Attachment-14 Departmental and Agency Comments

SUBJECT **Engineering Comments**
115 Watson Parkway North Zone Change (3rd Submission,
OZS24-015) and
115 Watson Parkway North Draft Plan of Subdivision
(2nd Submission, OZS25-014)

**RE: 115 Watson Parkway North – Engineering Comments
(OZS24-015 and OZS25-014)**

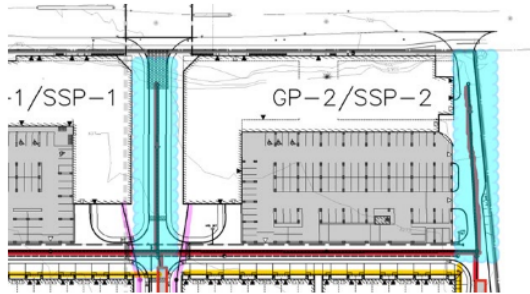
onsite storm sewer collecting surface water from Block 2, that goes from CBMH1 to CBMH2 and CBMH4 to CBMH5 (highlighted in blue below), crosses property lines and connects to the storm sewer within Block 3. The outlet for the storm sewer on Block 3 discharges to the 2400 x 1200 box culvert, municipal storm sewer on Watson Parkway North. A review by staff in Building Services has confirmed that these sections of onsite storm sewer would be considered a shared service in accordance with the OBC.

The drainage catchment area in question, catchment 208 in the FSR (Figure 3.0), is to be revised during detailed design to maintain drainage within each property. Since this will change the overall site stormwater drainage design, the applicant will be required to address this prior to rezoning the lands or prior to removal of the "H" (Holding Provision) to ensure that the City's stormwater criteria can be addressed and to demonstrate that there is adequate and available stormwater infrastructure for the proposed subdivision.
